**Addendum #3**  
**Doug Shaw Stadium Improvements**  
**December 21, 2016**

DOUG SHAW STADIUM IMPROVEMENTS  
MYRTLE BEACH, SOUTH CAROLINA

## **Doug Shaw Stadium Improvements**

### **Existing Concrete Grandstand Surface Preparation and Coating Schedule**

Drawing No.: **S1.0**

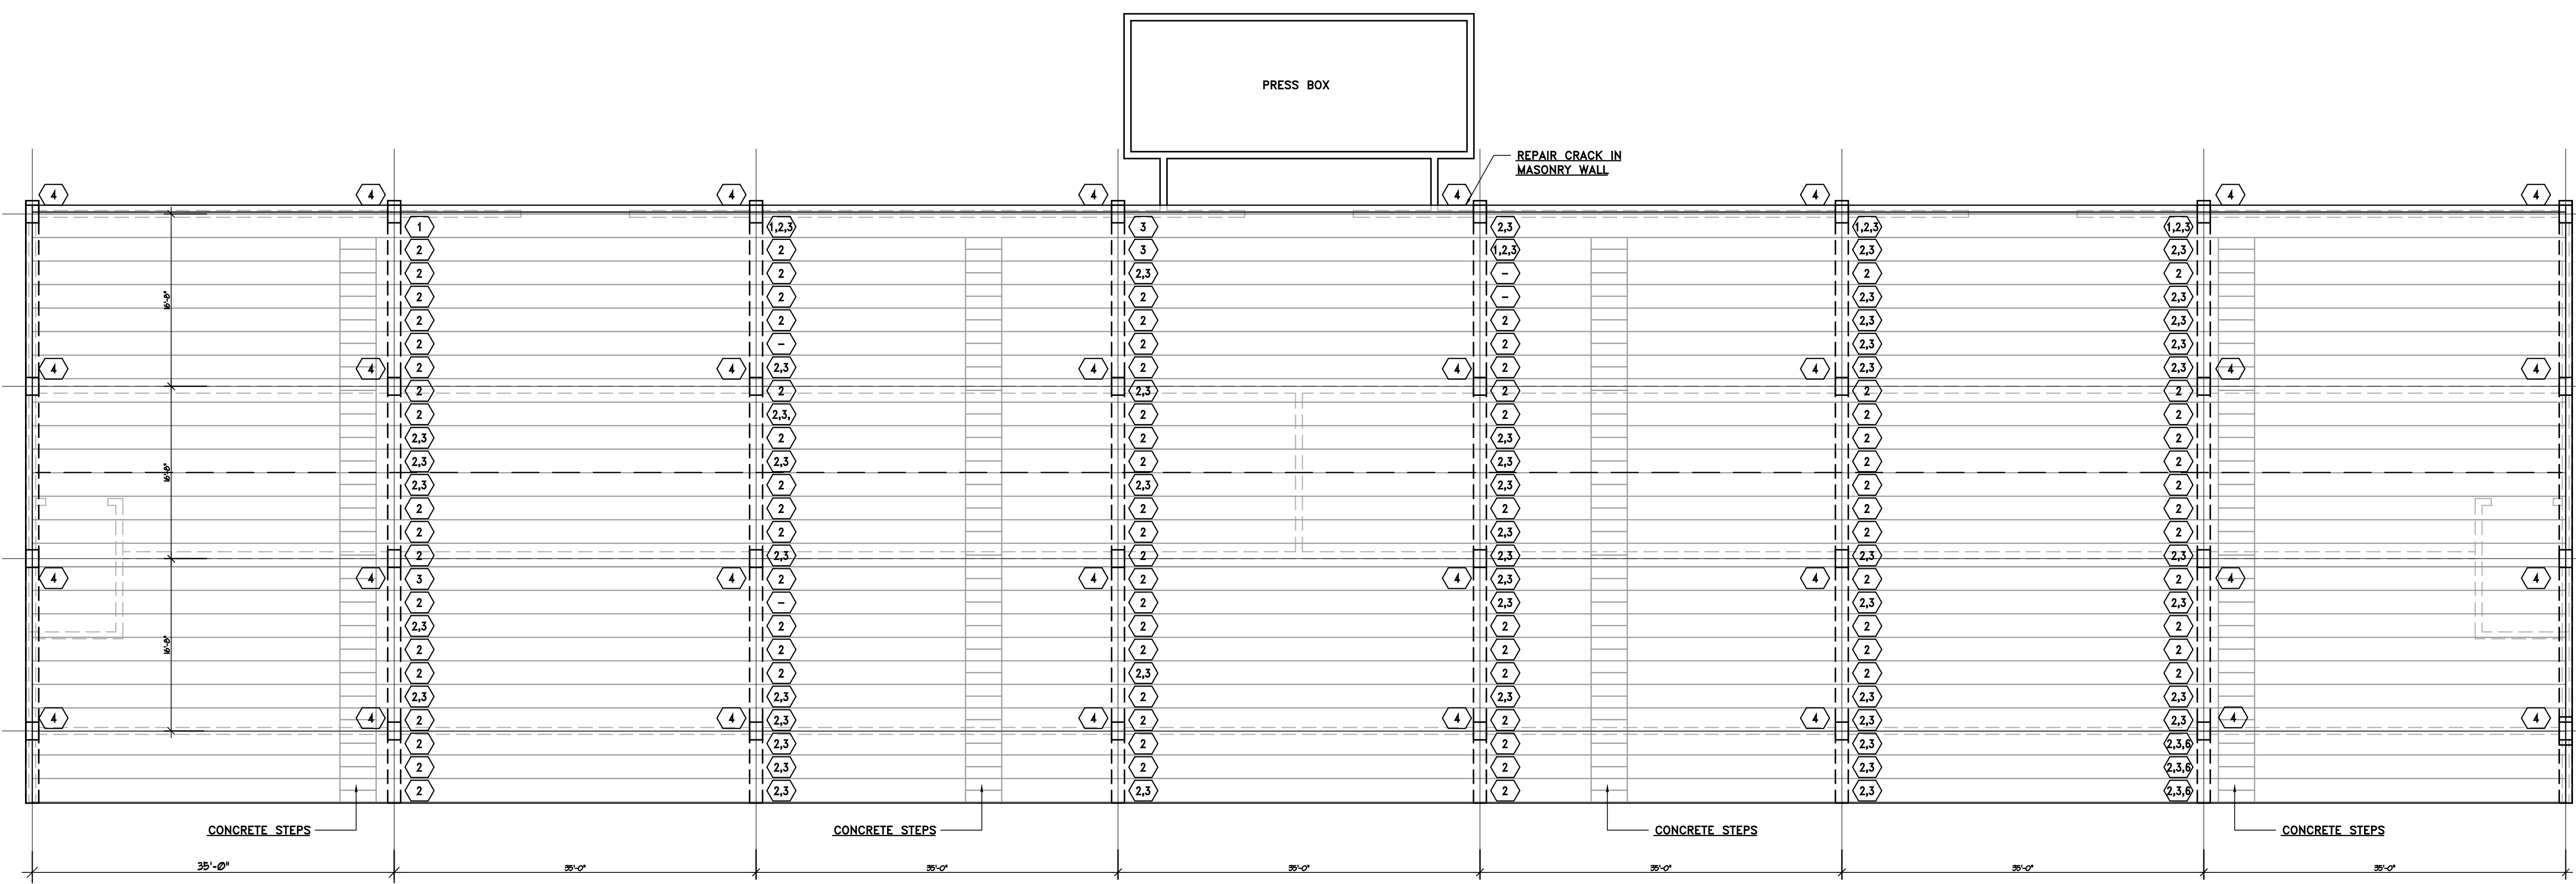
1. Please see attached structural repair drawings S1.0 and S2.0 for the existing concrete grandstand.
2. Please see attached coating schedule for existing home grandstand.

9. **Question:** There is a note on Drawing A101 that states "Existing Concrete Grandstand – Repair and Recoat". Additionally, there is a specification Section 030130 Maintenance of Cast In Place Concrete which I assume is for the repair of the Grandstand.

- a. Can you provide a quantity for the repairs? Or better yet provide an allowance so we are all bidding the same amount?
- b. What type of material are we to use to recoat the grandstand?
- c. Are we to recoat underneath existing brackets?

**Answer:** Please see attached drawings S1.0 and S2.0 providing scope and details of the grandstand repairs. Please see attached coating specification for type of material to recoat the grandstand. The coating specification requires removal of the existing brackets and grandstand coating.

REPAIR 5 - ASSUME FIVE LOCATIONS.

REPAIR 1 - ALL STEMS OF DOUBLE-TEE CONNECTION TO RAKER BEAM. (ONLY ONE STEM IS CONNECTED, THE OTHER STEM BEARS ON ADJACENT DOUBLE-TEE)

REPAIR 6 - OCCURS ON UNDERSIDE OF DOUBLE-TEE SEATING. CONTRACTOR SHOULD VISIT SITE TO DETERMINE QUANTITY OF REPAIR.
